UNITED STATES PATENT AND TRADEMARK OFFICE

APPLICATION NO.	FILING DATE	FIRST NAMED INVENTOR	ATTORNEY DOCKET NO.	CONFIRMATION NO.
10/023,284	12/15/2001	Donald P. Kenney	11109-00006	7592
27160	7590	12/19/2005	EXAMINER	
KATTEN MUCHIN ROSENMAN LLP 525 WEST MONROE STREET CHICAGO, IL 60661-3693			KOCZO JR, MICHAEL	
			ART UNIT	PAPER NUMBER
			3746	
DATE MAILED: 12/19/2005

DETAILED ACTION

Fig. 3.

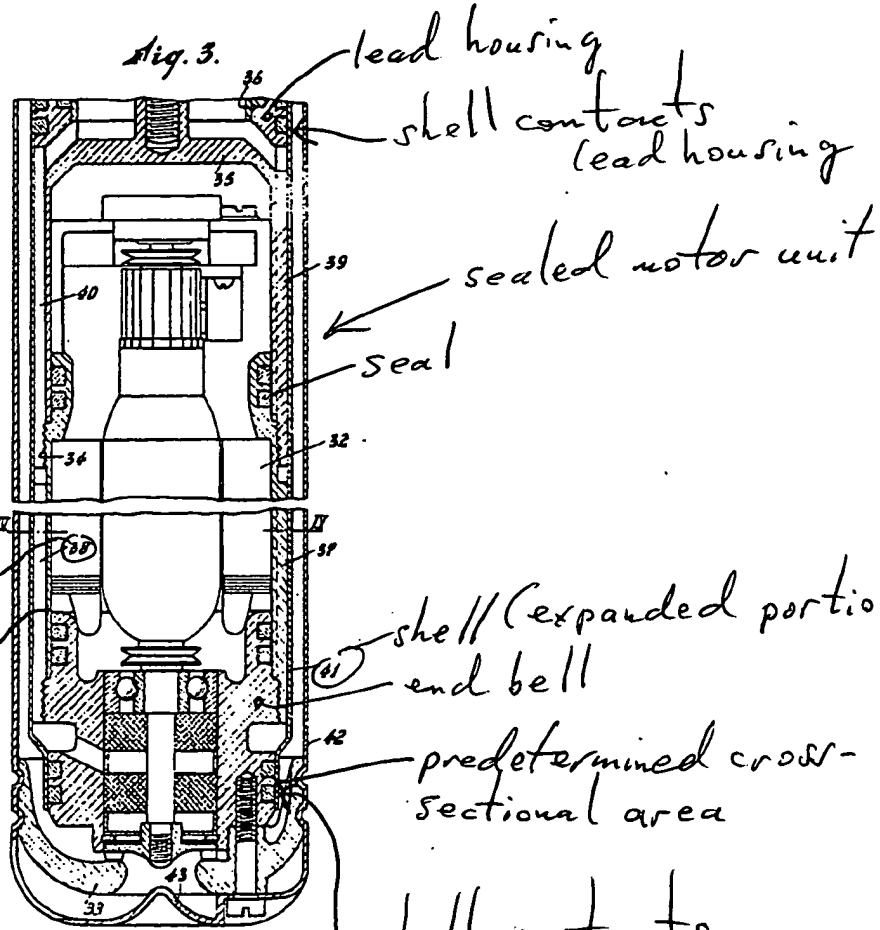
Claims 2, 3, 4, 5, 9, 11, 15, 22 and 23 are rejected under 35 U.S.C. 102(b) as being anticipated by Avigdor (CH 207,150). See attachment "A" which shows figure 3 with the claimed structure identified. Figure 3 shows a sealed motor unit having a motor housing, a pump assembly having a predetermined cross-sectional area, and a shell 41 having an expanded portion that is relatively larger than the predetermined cross-sectional area. A cavity 38 is formed between the shell 41 and the motor housing. The shell contacts the end bell and the lead housing. The shell 41 inherently aligns the pump assembly components to the motor unit since it is connected to both. See figure 5 which shows the pump 69 submerged in a tank 67 and connected to a manifold which leads to dispensers 74. Regarding claim 23, the flow rate of an electric motor driven pump is inherently capped (limited) by its design.

lead housing
shell contacts
lead housing
sealed motor unit
seal
shell (expanded portion)
end bell
predetermined cross-sectional area
shell contacts
end bell
